**KEYSTONE XL PIPELINE PROJECT PHASE II
PIPELINE ROUTE VARIATION FORM**

0166-SD-P2-295.1-295.7-S

KEYSTONE XL PIPELINE PROJECT PHASE - STEELE CITY SEGMENT ROUTE VARIATION AUTHORIZATION FORM	
Date: <u>4/23/2010</u> Description: <u>Reroute at Kimble Creek to avoid a long bore and significantly deep (> 20 ft) bore pits.</u>	Tracking Number: <u>0166-SD-P2-295.1-295.7-S</u> MP: <u>295.1</u> to <u>295.7</u> Originated By: <u>Engineering</u> Variation Form Attached: Yes <input checked="" type="checkbox"/> No <input type="checkbox"/>
Universal Field - Land Doug Reichley Comments: <div style="border: 1px solid black; height: 40px; width: 100%;"></div>	Variation: Approved <input checked="" type="checkbox"/> Rejected <input type="checkbox"/> <u>Doug Reichley</u> Date: <u>4/28/2010</u> If Rejected Why? <div style="border: 1px solid black; height: 40px; width: 100%;"></div>
State PM - Construction / Eng. David Guien Comments: <div style="border: 1px solid black; height: 40px; width: 100%;"></div>	Variation: Approved <input checked="" type="checkbox"/> Rejected <input type="checkbox"/> <u>David Guien</u> Date: <u>4/26/2010</u> If Rejected Why? <div style="border: 1px solid black; height: 40px;

**KEYSTONE XL PROJECT - STEELE CITY SEGMENT
PROPOSED ROUTE VARIATION 0166
HARDING COUNTY, SOUTH DAKOTA**

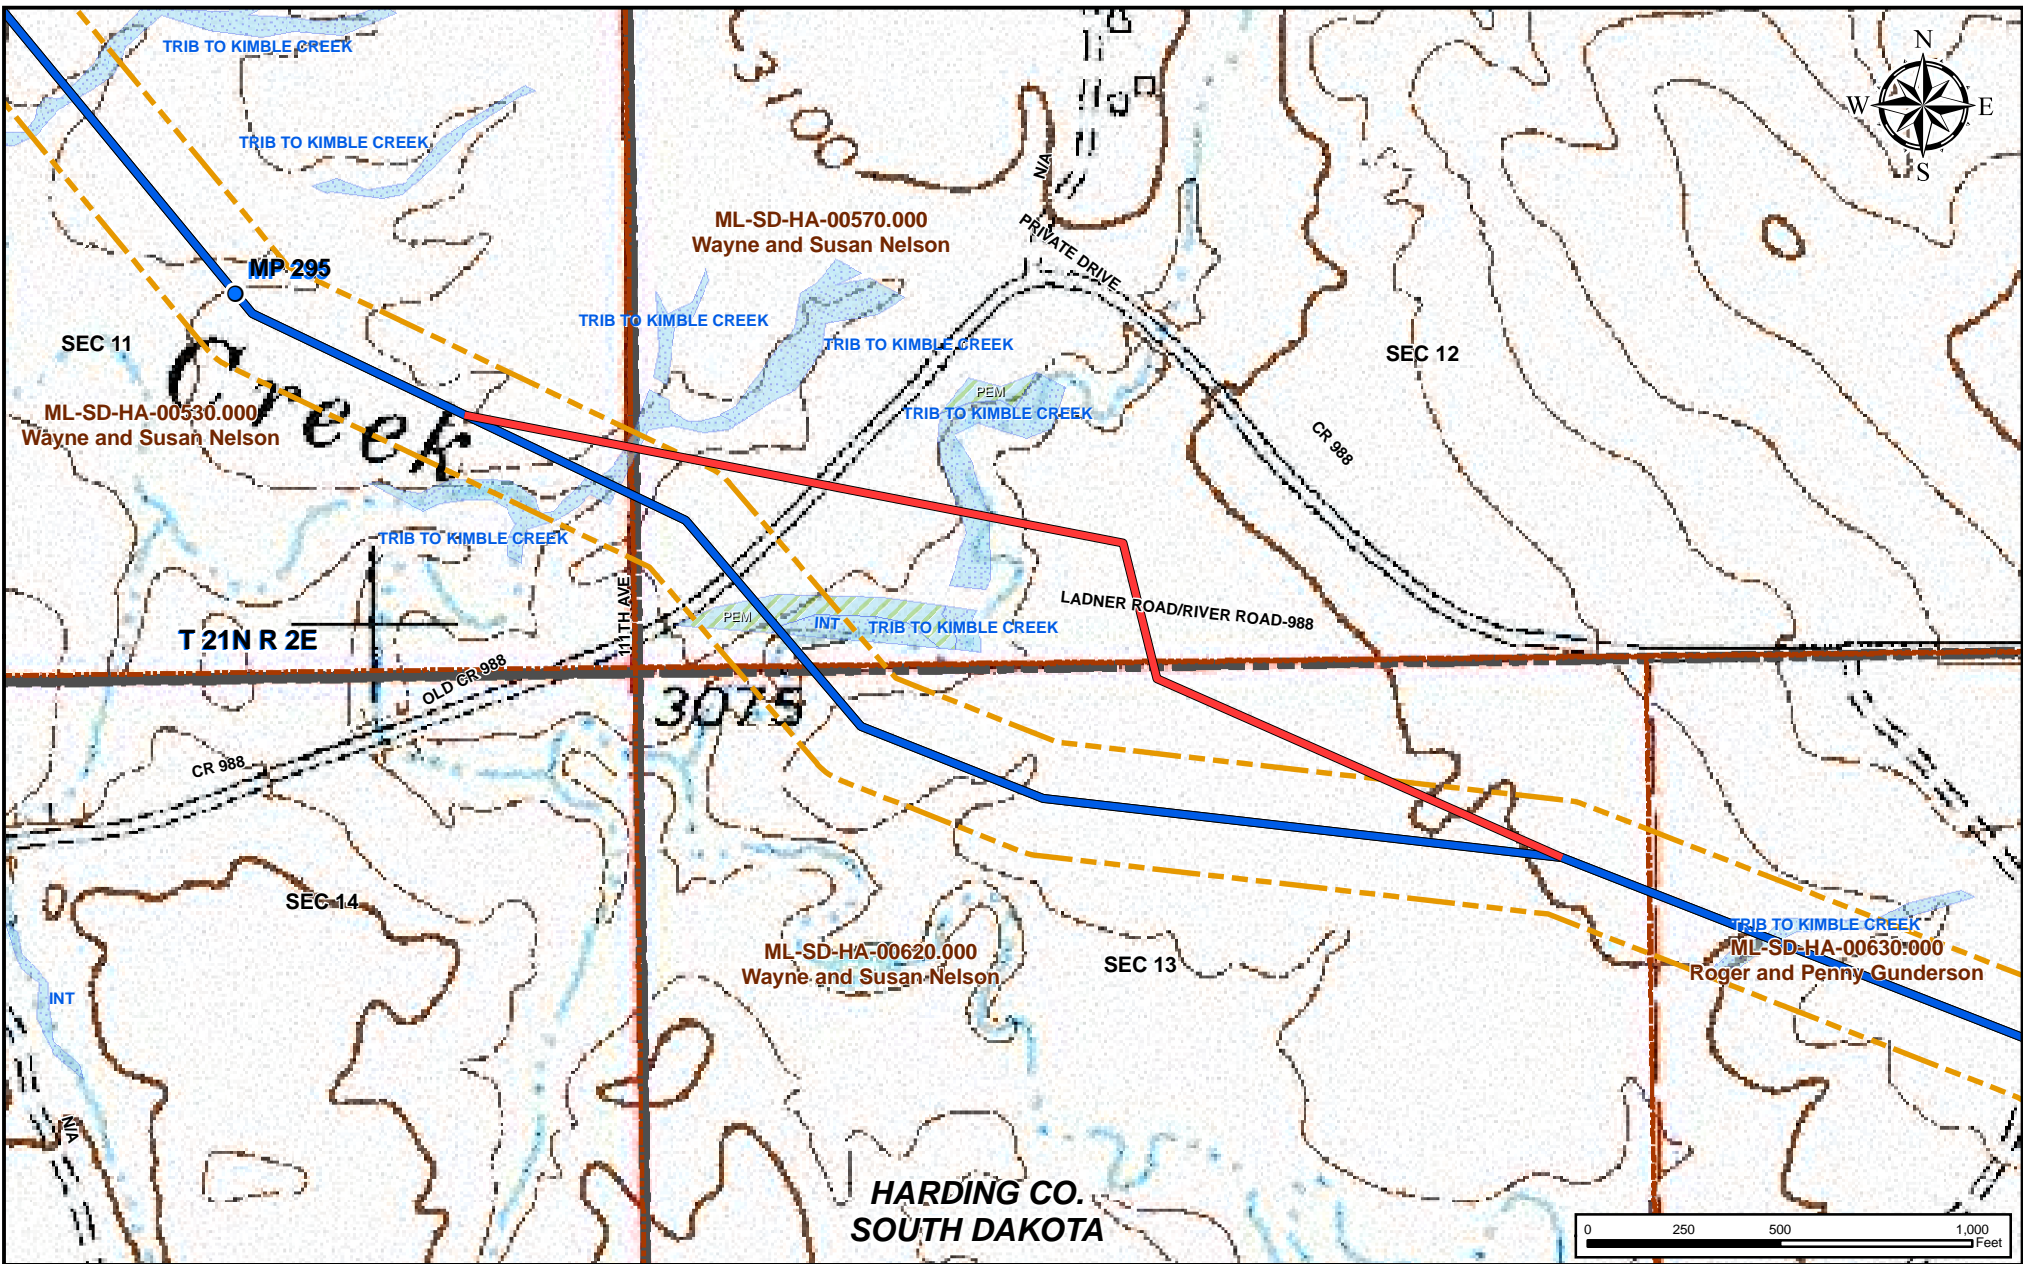
DETAIL ROUTE VARIATION (Please describe route variation in detail):			
<p>The proposed reroute starts at ~MP 295.1 and deviates (~15°) from the centerline towards the east. It continues in this direction for 1,750 ft, crossing the Tributary to Kimble creek along its path. From here it turns towards the south and continues for 360 ft, along its path it crosses County Road 988 approximately 880 ft east of its current crossing location. The current location of the road crossing location is approximately 120 ft away from the landowner's private drive to avoid any construction impacts to it. The proposed reroute then turns towards the east and continues for 1,320 ft to rejoin the current centerline at the PI near MP 295.7.</p>			
ADDITIONAL IMPACTS (Please include any additional impacts which may affect cost; crossings, induction bends, etc.):			
<p>The proposed reroute is approximately 53 feet longer than the current centerline. The road bore for the County Road - 988 is reduced from 320 ft to 80 ft. The proposed reroute avoids two engineered pits on either side of the bore crossing location (required for the current bore location). The cost savings due to the elimination of the engineered pits is roughly estimated to be \$580,000 based on a cost for shoring of the trench for the bore pit and well points to avoid flooding of the bore pit.</p>

Is there an increase/decrease in the number of crossings? Yes <input checked="" type="checkbox"/> No <input type="checkbox"/>			
If yes, please list: <input type="text"/> Increase in one waterbody crossing (Open Cut <20 ft wide) which was earlier planned to be bored.			
COST ANALYSIS (costs incurred or saved from the route variation)			
Additional length of route realignment:	<input type="text"/> 53 ft.	\$ <input type="text"/> 31,544.01	\$ 360/ft
Additional length of side-hill construction:	<input type="text"/> ft.	\$ <input type="text"/> -	\$ 19/ft
Additional length of wetland construction:	<input type="text"/> ft.	\$ <input type="text"/> -	\$ 195/ft
Additional bore length (Road, RR):	<input type="text"/> -240 ft.	\$ <input type="text"/> (129,600.00)	\$ 540/ft
Additional foreign line/pipeline crossings:	<input type="text"/> EA	\$ <input type="text"/> -	\$ 30,000/EA
Additional water body crossing (streams, ponds, etc.):
